Project Title:	OUR TOWN HALL		
Project No:	1620003165		
Sketch No:			
Title:	Kitchen link strengthening options		
Scale:	NTS		
Eng:	Rev:	Date:	Checked:
SK	01	09/08/2019

From: Gary Willis
Sent: 19 August 2019 12:27
To: gareth.richings@purcelluk.com; Thomas.Kirby@purcelluk.com
Cc: Davis, Daniel; Isherwood, Kelly; 'David Hanna'; Paul Maddison; Bentley, Liam; Stelios Koukakis
Subject: RE: OTH - Former Bridge Link
Attachments: Ramboll SK 1 (19.08.19).pdf; Ramboll SK 2 (19.08.19).pdf; Ramboll SK 3 (19.08.19).pdf

FORMER KITCHEN LINK

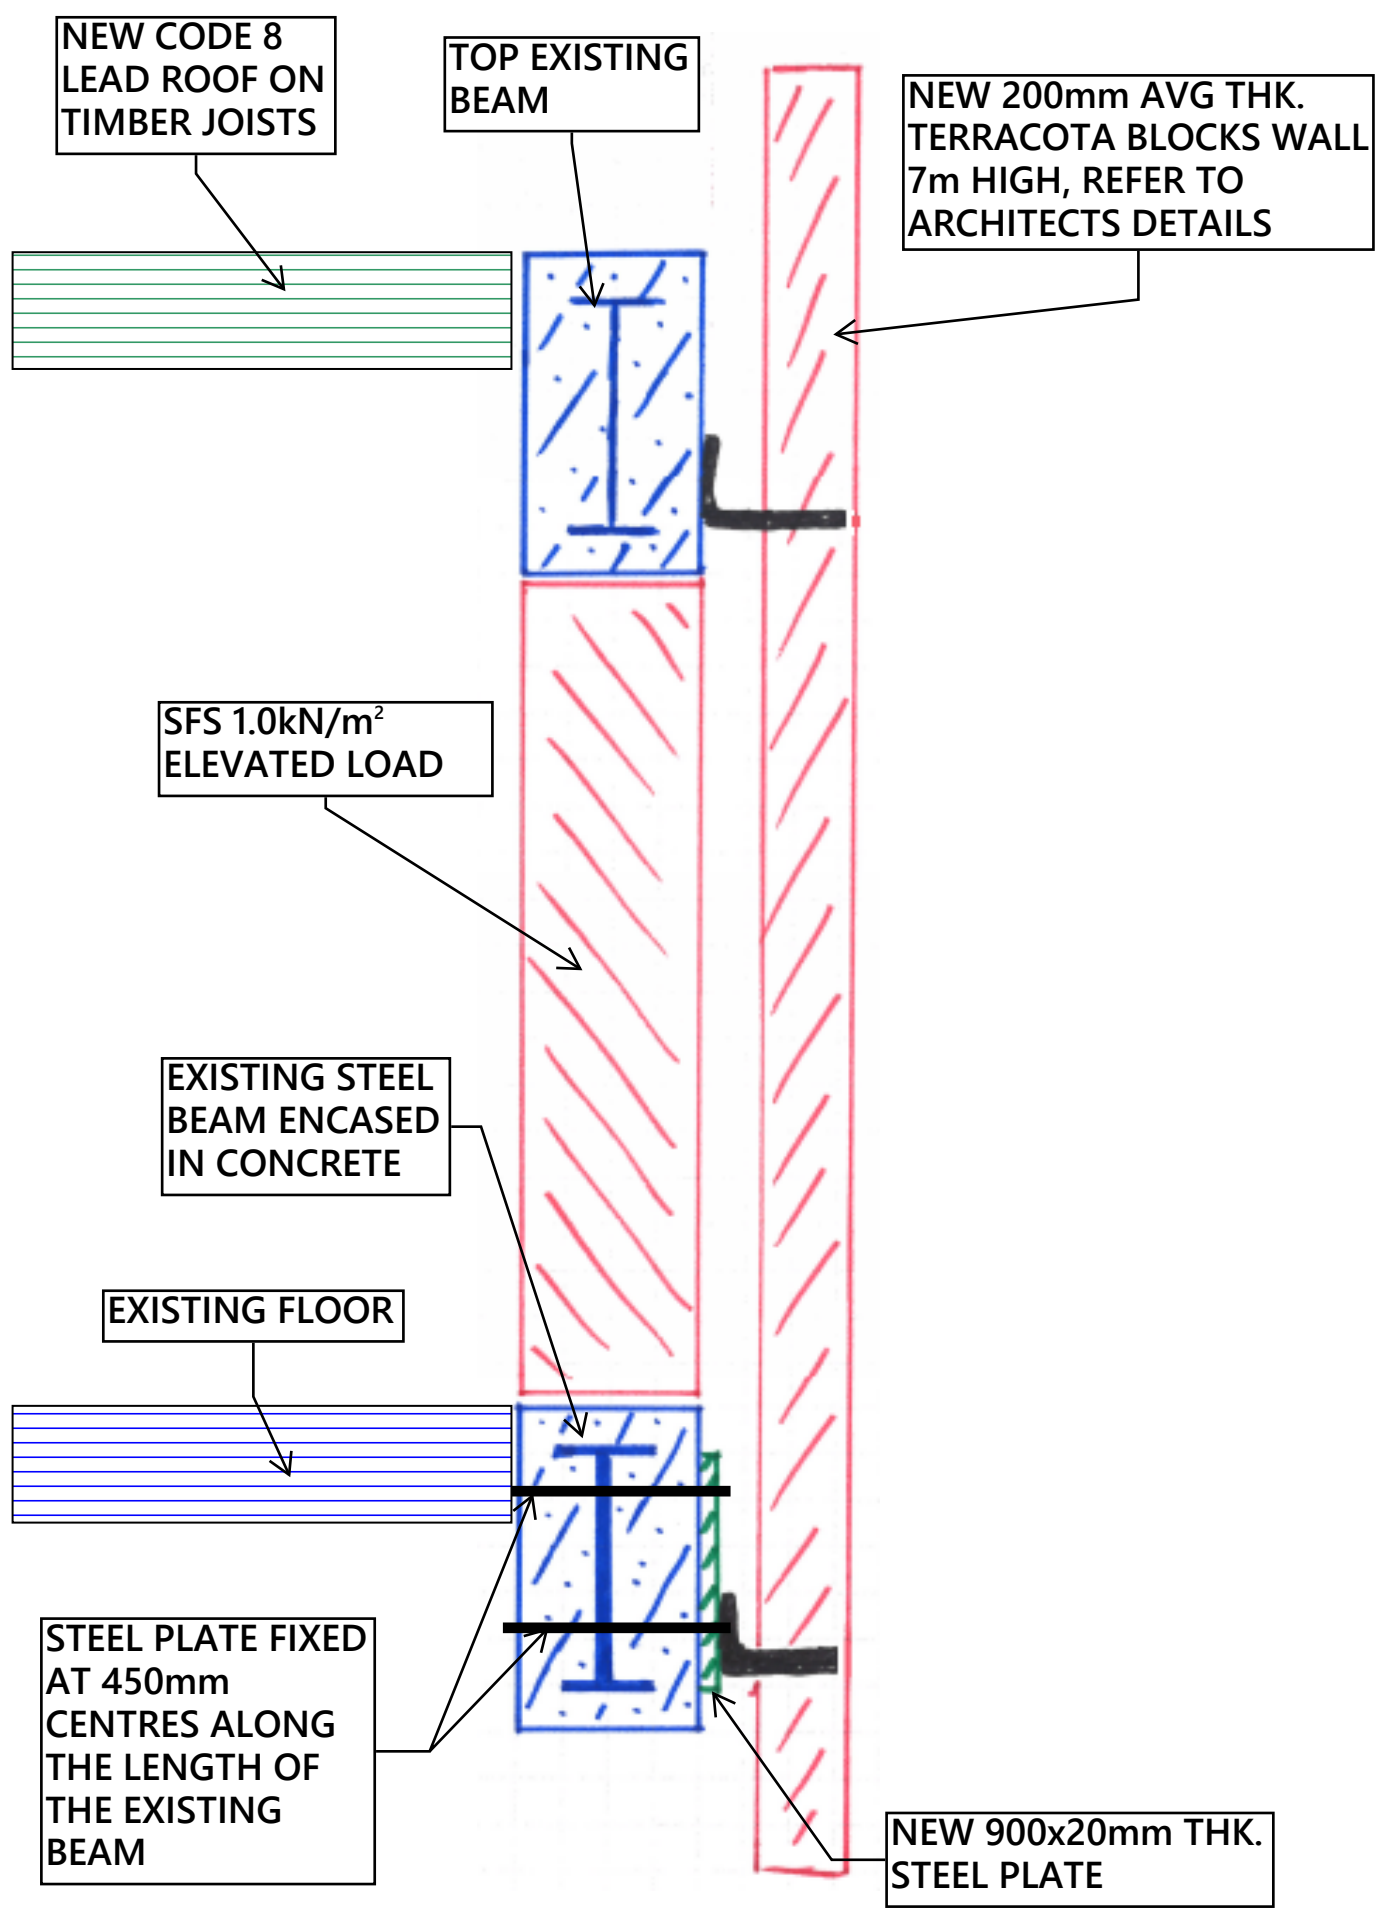
OPTION 1
Strengthening Plate

OPTION 2
Strengthening Beam

- Plate fixed to the face of the existing 1000mm deep concrete encased steel beam = 900x20mm (or 850x25mm), see attached sketch titled Alternative Options*
- Beam section attached to the top of the 450mm wide concrete encased steel beam (hidden within the wall line) could be; UB 686x254x170, UB 610x305x179 or a UC 356x406x467

* the plate could also provide a fixing points for the masonry support angle. See below.

The sizes of steelwork noted above are driven but limiting deflection rather than have sufficient strength, over this almost 12m span. With a better understanding of permitted deflections (use of solf/lime mortar) and when deflections occur) these sizes might reduce. Similarly if the cladding weight is reduced from 200mm thick and 7m high the steel sizes could reduce.

High-level section through west elevation

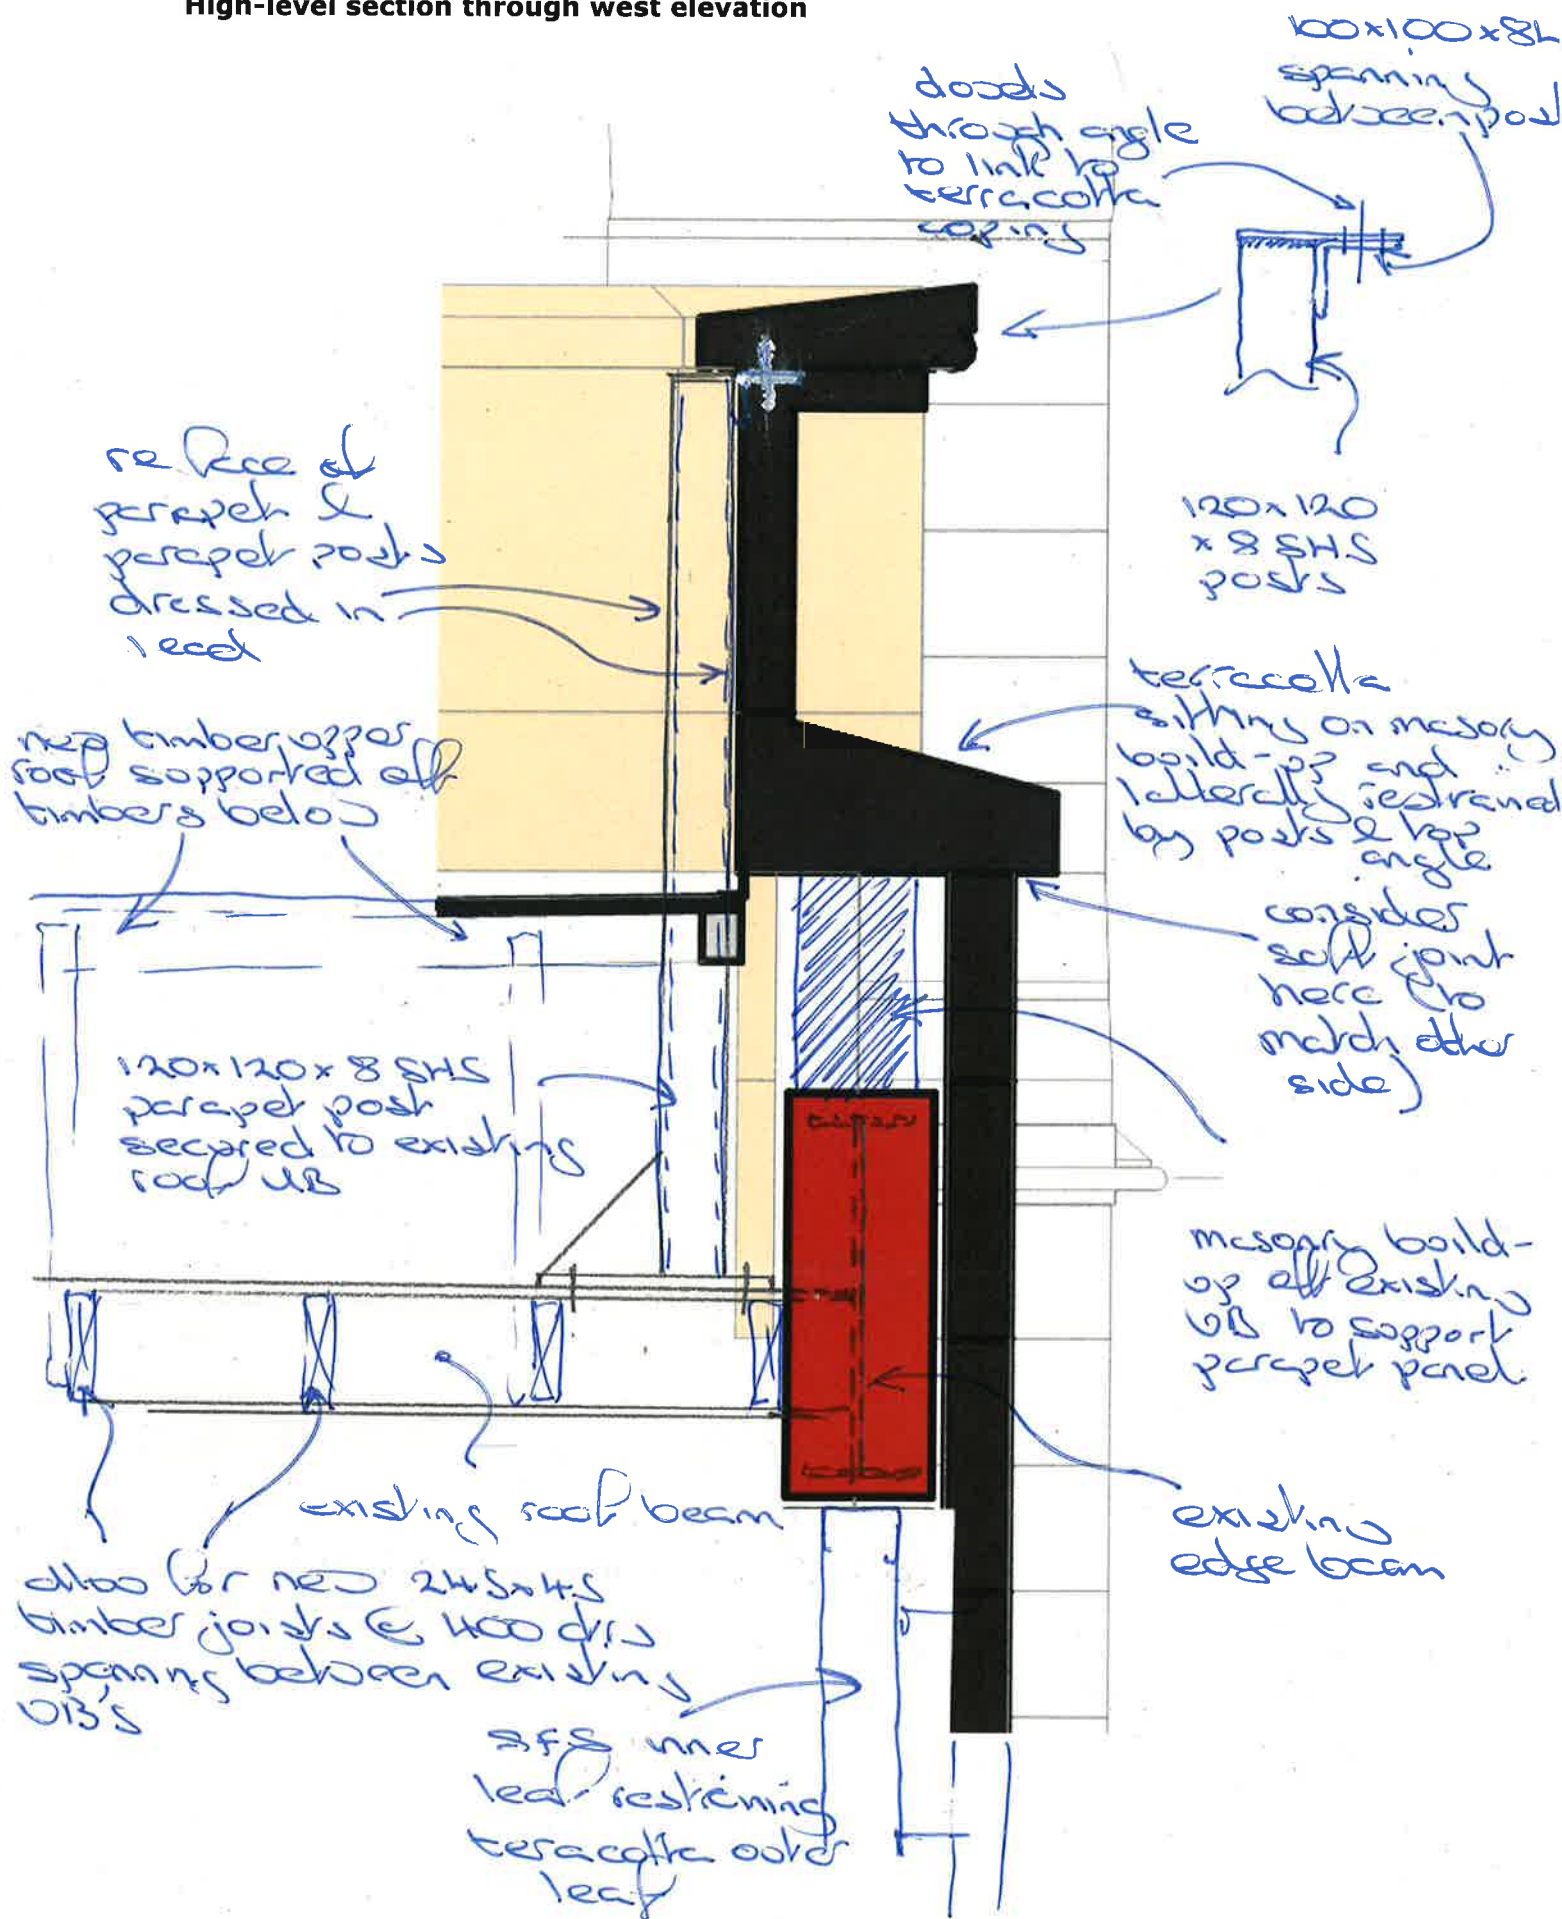
SK 1 (west elevation)

- 120SHS posts secured to the existing steel roof beams cantilever up and laterally restrain the terracotta parapet panel. I have shown a 100x100 angle spanning between the tops of the posts, which the coping stone can be secured to via dowels. Any similarly stiff horizontal steel element could be provided at this level that better integrates with the terracotta panel/coping.

- Currently the posts are shown to the rear face of the parapet panel, hence would be dressed/concealed in lead as suggested at the meeting. Given the size, Purcell could now explore integrating this post within the depth of the parapet panel (they are at the same centres as the existing roof beams they are secured to, which is roughly 3m ctrs).

- The vertical load of the parapet panel is supported via a masonry build-up off the top of the existing steel beams (we need to coordinate the gable returns with the location of the existing roof beams)

Section through east elevation

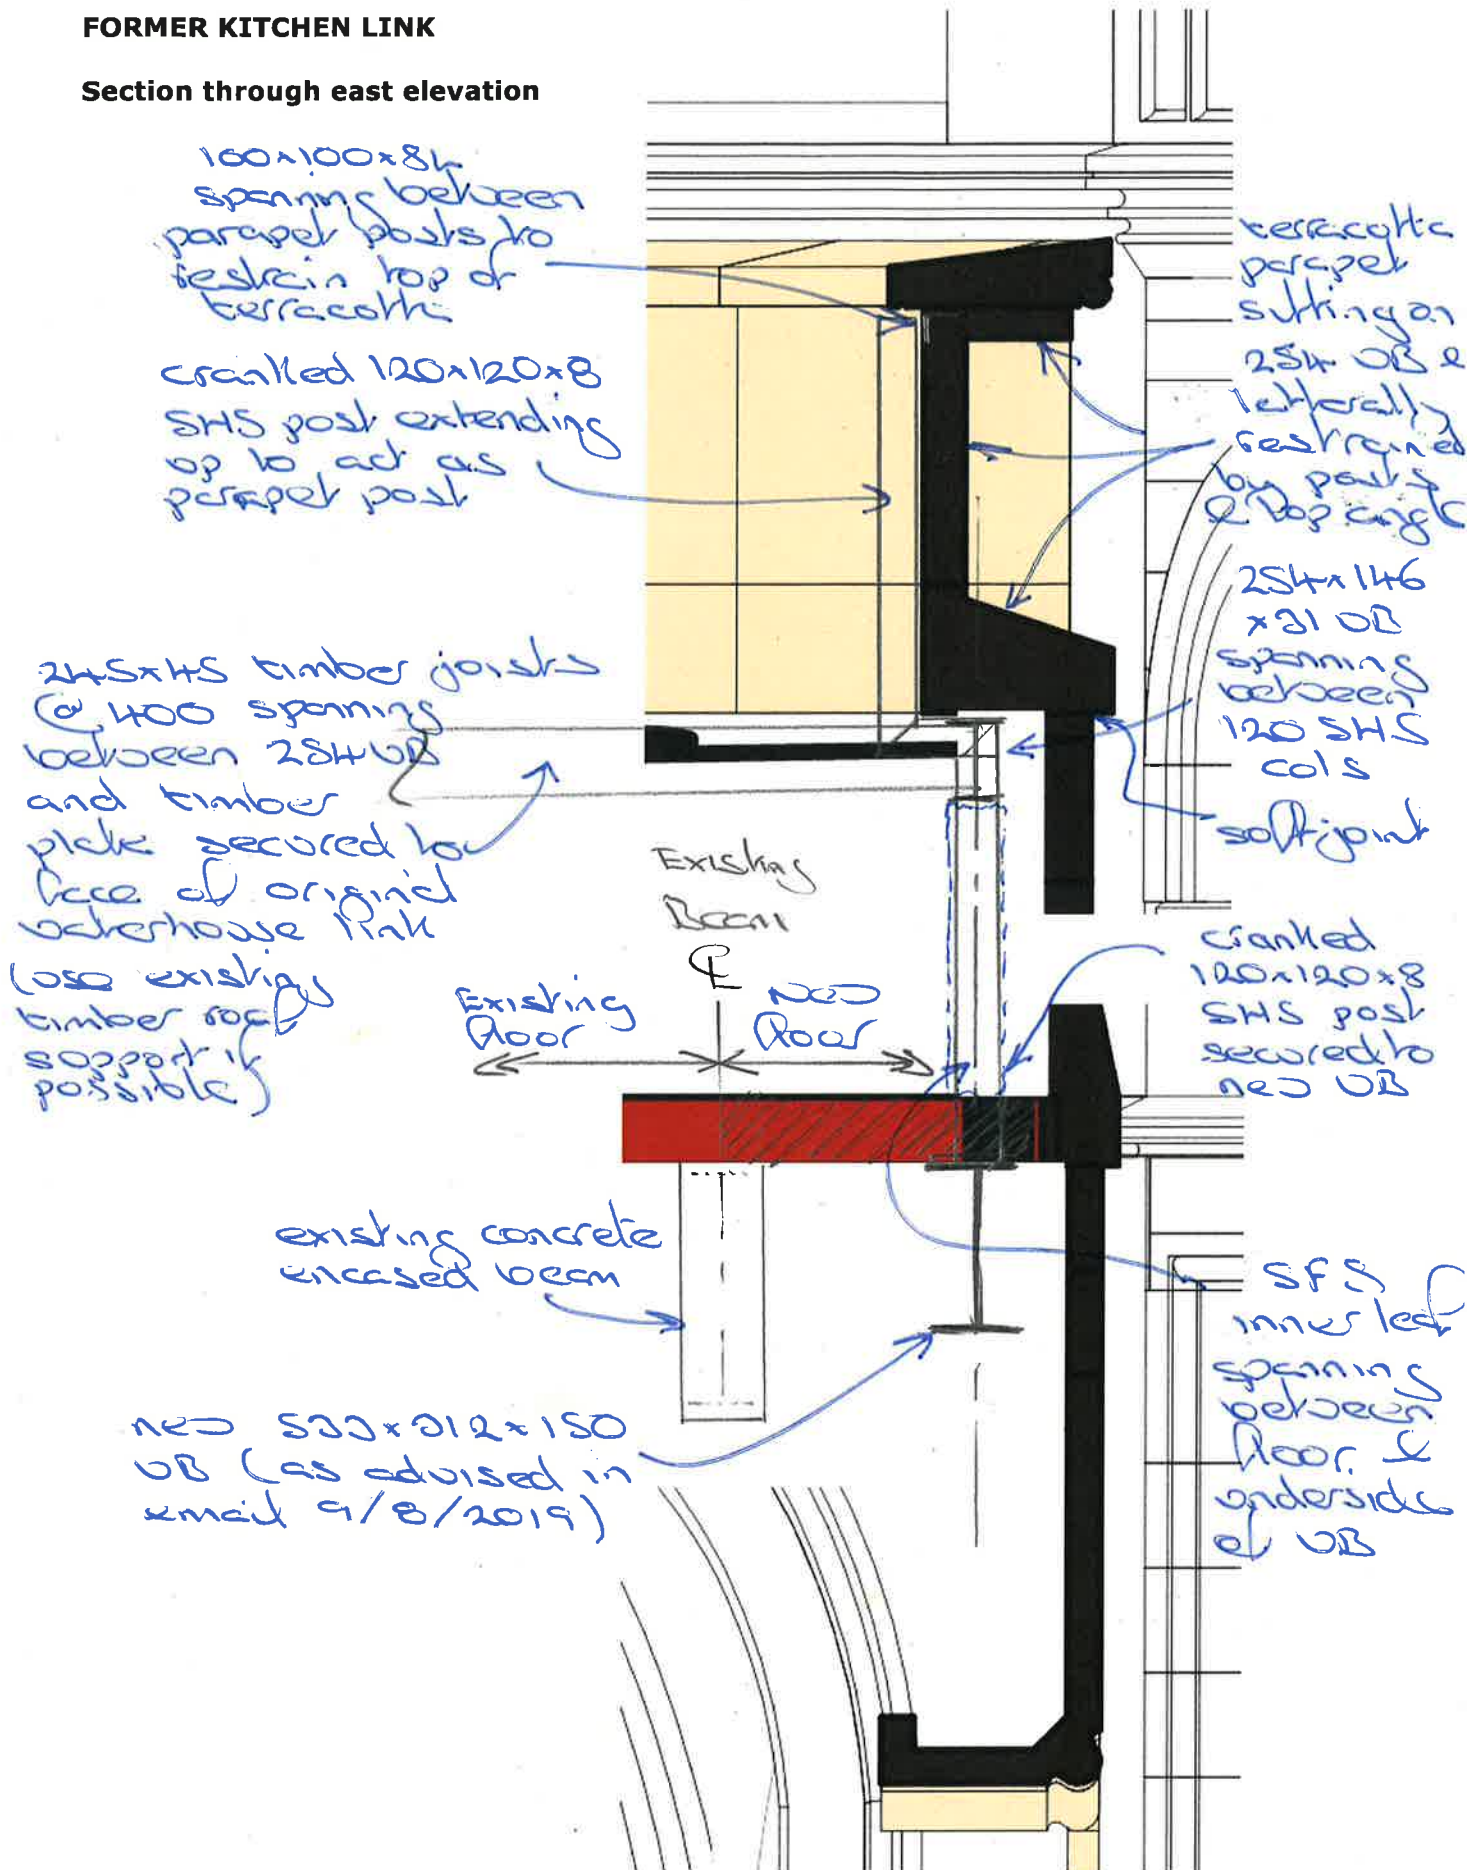
SK 2 (east elevation)

- With only an SFS inner leaf, there is nothing to vertically support the terracotta parapet panel!!!!
- To laterally restrain the panel we have used double-cranked 120 SHS posts, which are centred on the new steel floor beam at their base and are concealed in the zone of the SFS inner leaf. They have a double crank at the top, to cantilever up at the top to restrain the parapet panel in the same manner as on the west side (with a 100x100 horizontal angle or similar along the top)

- Spanning between these posts, at roof level, are 254 UB's which: vertically support the terracotta parapet panel, vertically support the incoming timber roof joists, and offer a point to secure the SFS to from below.

- There will inevitably be some differential movement between the parapet panel and the terracotta outer leaf spanning up from below. We should therefore allow for a soft horizontal joint between these elements as shown. This should be replicated throughout.
